Item ID: D206-642-341BL

Item Name: Replacement Skidtube (Fits LH or RH)

DRAWING NO. D2650	TITLE 206/407 SKIDTUBE ASSEMBLIES	REV. F	DART AEROSPACE LTD ENGINEERING ORDER		D.E.O. NO. D2650-F-1	SHEET NO. SHEET 1 OF 1	SCALE NTS
DRAWN <i>[Signature]</i>	CHECKED A.P.	MFG. APPR. <i>[Signature]</i>	APPROVED <i>[Signature]</i>		DE APPR. <i>[Signature]</i>		
DATE 12.10.12	DATE 12.10.22	DATE 12.10.22	DATE 12.10.22		DATE 12.10.22

CHANGE C'BORED WELDED CROSSBOLT SPACERS TO SWAGED SPACERS

DETAIL G

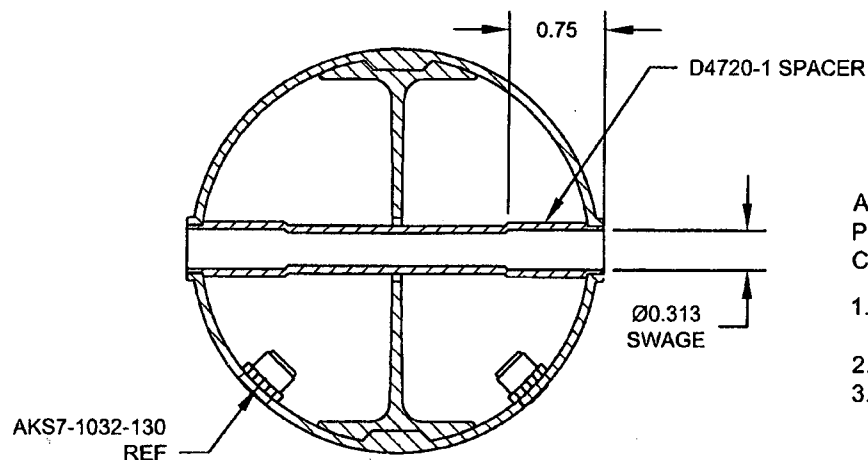
ADD DETAIL G BELOW, WHICH IS THE SAME SECTION VIEW AS DETAIL D OF DWG.
C'BORED HOLES ARE **NOW SWAGED** PER DETAIL G BELOW. FOR THE Ø0.375 HOLE THAT IS NOT C'BORED, WELD PER DETAIL D OF DWG (SEE AMENDED DETAIL B FOR REFERENCE).

FOR Ø0.375 HOLES ONLY

FOR HOLES THAT ARE CURRENTLY C'BORED ONLY

AFTER DRILLING AND BENDING ASSEMBLY
PERFORM THE FOLLOWING FOR Ø0.375 HOLES THAT ARE
CURRENTLY C'BORED:

1. INSERT D4720-1 SPACER, 16 PL (-1) OR 17 PL (-3)
OR 19 PL (-5) OR 23 PL (-7)
2. SWAGE TO Ø0.313 X 0.75 DP PER QSI 002
3. TRIM / GRIND FLUSH PER QSI 002
